PUBLIC UTILITIES COMMISSION

RE: Request for Additional Data – Certificate of Public Convenience and Necessity for the Sycamore-Peñasquitos 230 Kilovolt Transmission Line Project – Application No. A. 14-04-011

REQUEST FOR ADDITIONAL DATA: DATA NEEDS FOR THE SYCAMORE-PEÑASQUITOS 230 KILOVOLT TRANSMISSION LINE PROJECT APPLICATION (A. 14-04-011)

Attachment B: Access Roads and Biological Study Area

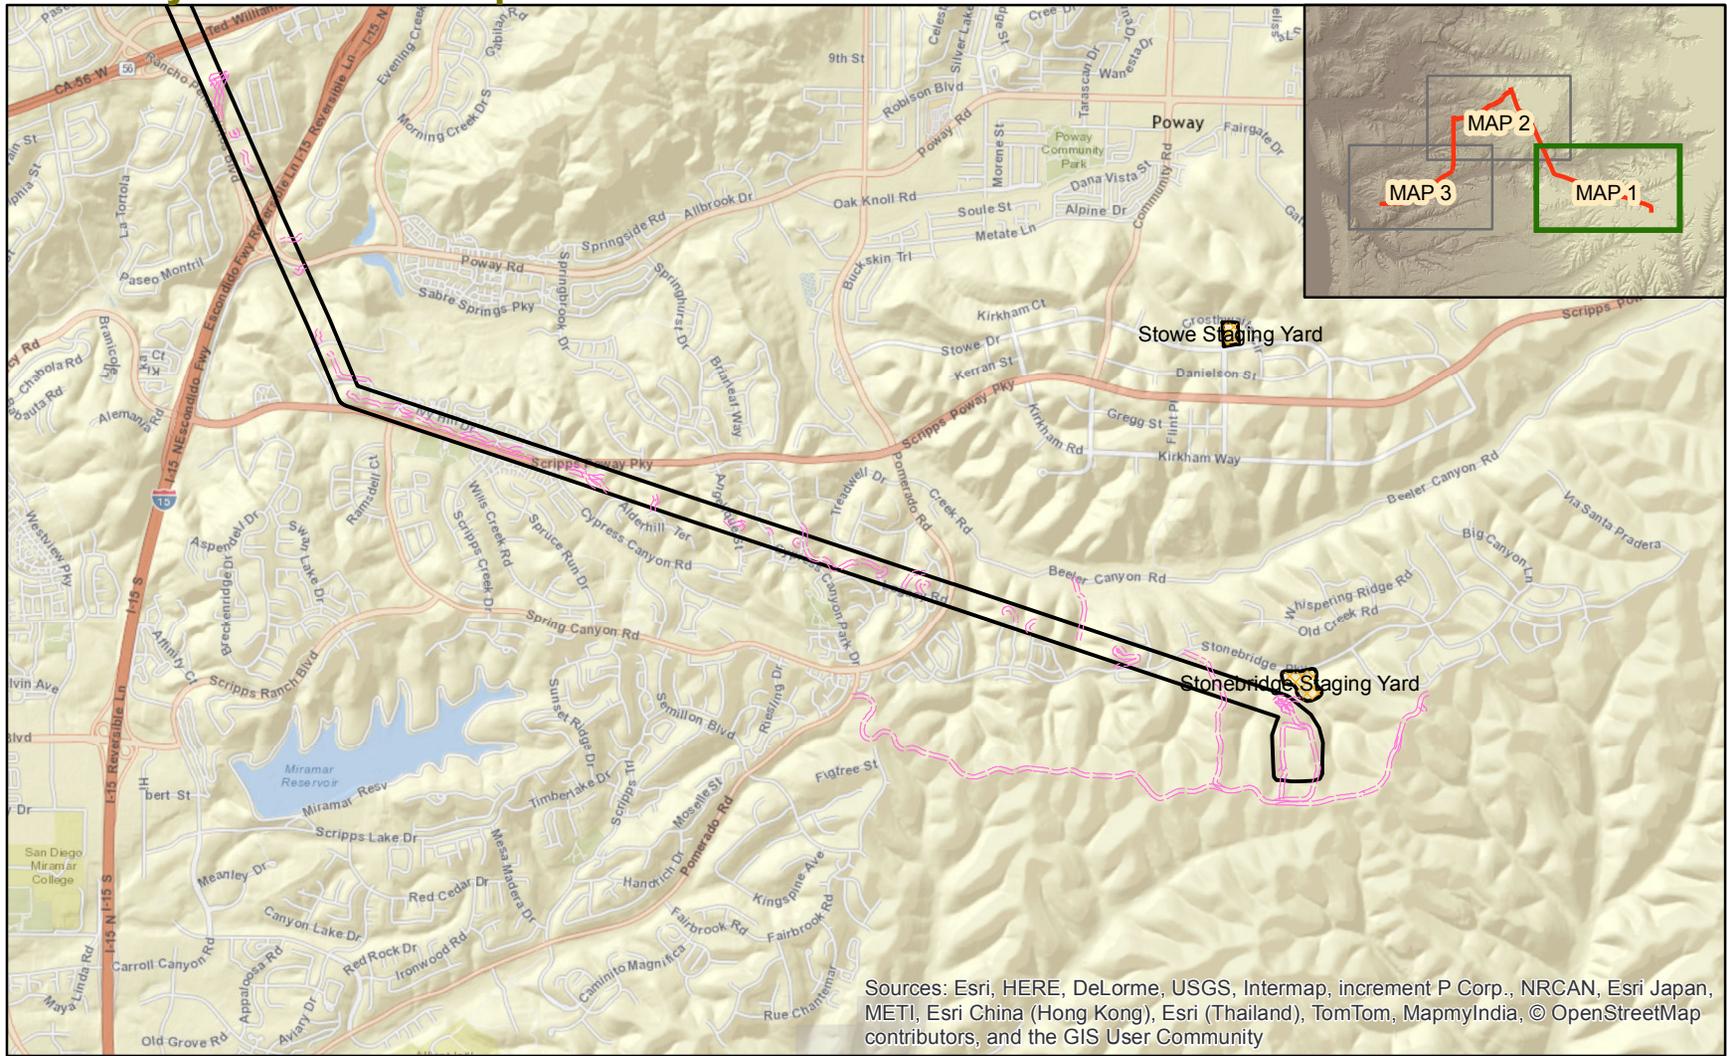
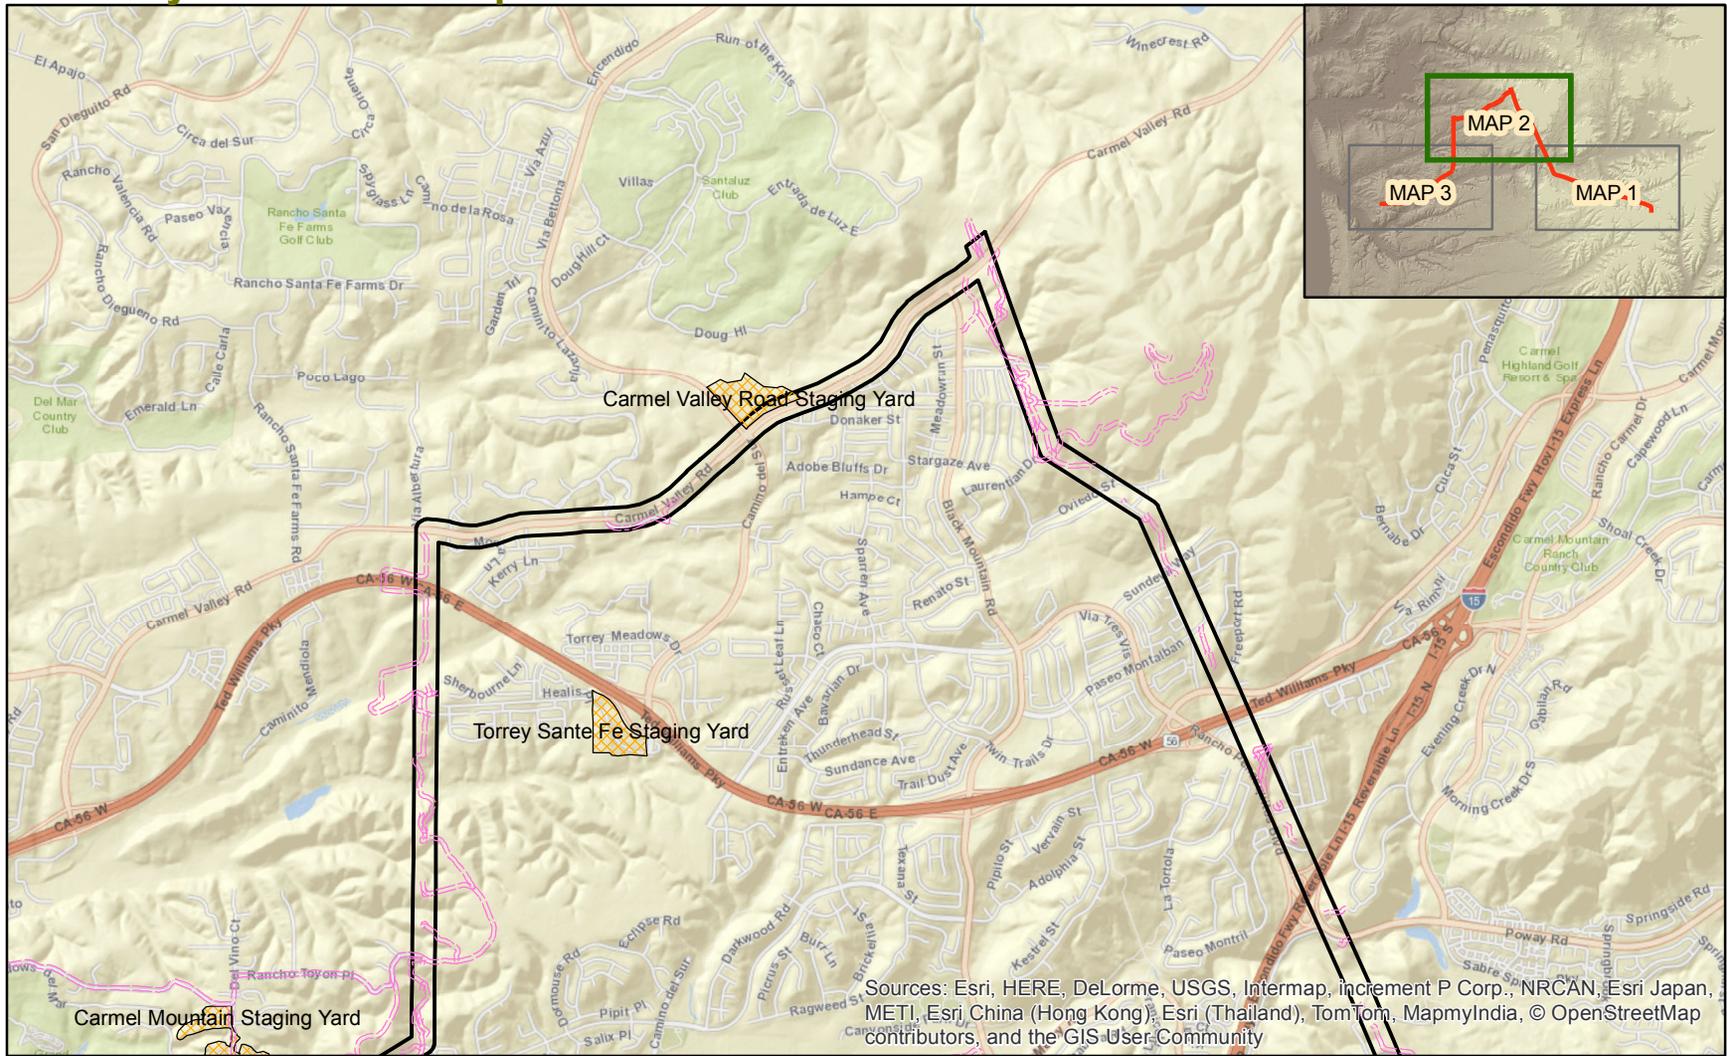
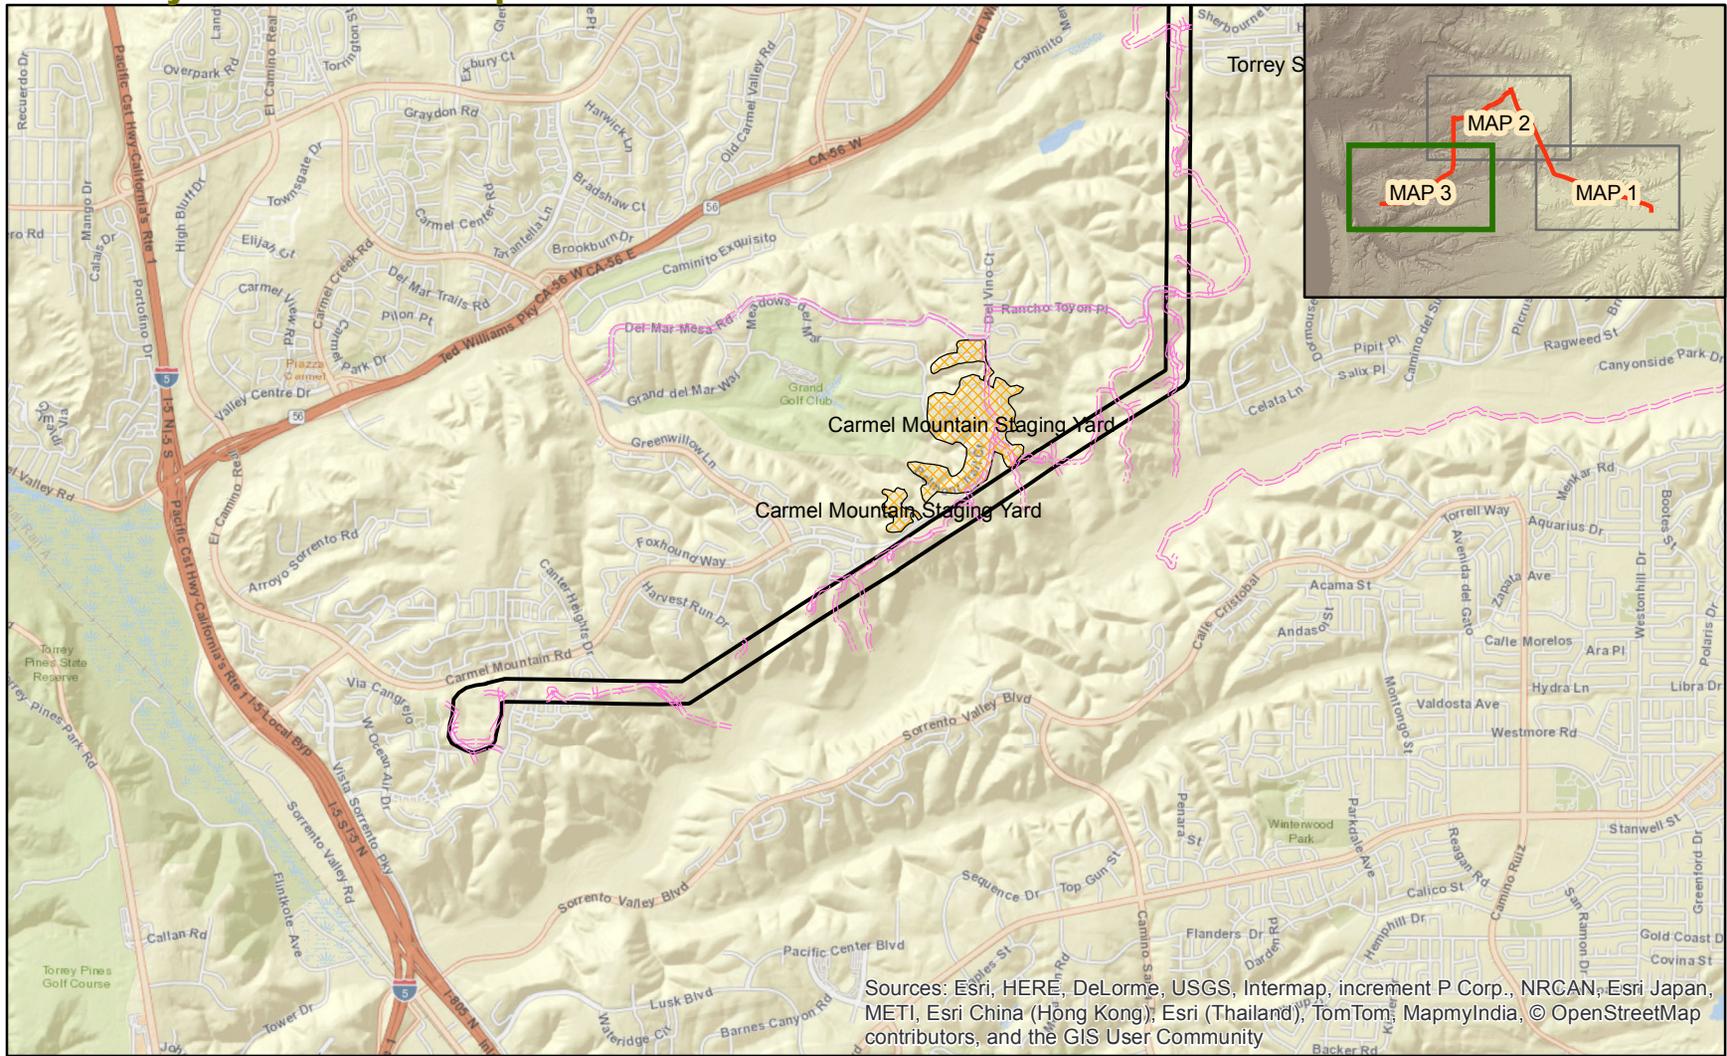
6	GIS Data	<p>Verify the access roads and length of each access road that will be used during construction.</p> <p>During the July 15, 2014 site visit SDG&E discussed that a number of access roads were included to provide flexibility for construction. A number of these access roads extend outside of the 500-foot project study area as shown in Attachment B. One access road is approximately 3 miles long and does not connect to any other access road or work area for the project. Please refine the access road lengths to be reasonable relative to the proposed use and provide associated updated GIS files. Please describe how the access road located south of the alignment and within the canyon bottom may be used for the project if SDG&E wishes to retain it as a work area for the proposed project.</p>
7	Appendix 3-B	<p>Identify alternate staging yards that SDG&E may use to replace the Carmel Mountain Staging Yard. Submit the revised GIS with updated staging yards to CPUC.</p> <p>Residential development was observed during the July 15, 2014 site visit in the Carmel Mountain Staging Yard. The CPUC later verified that this area has recent residential development and the remainder of the area is under construction; therefore, the Carmel Mountain Staging Yard is not a viable staging yard. This is a large staging yard for the project and the only staging yard proposed along Segment D.</p> <p>Identify any potential staging yards or landing zones that may be used during project construction to replace the Carmel Mountain Staging Yard. Revise the GIS data to show appropriate staging yards and submit to CPUC.</p>
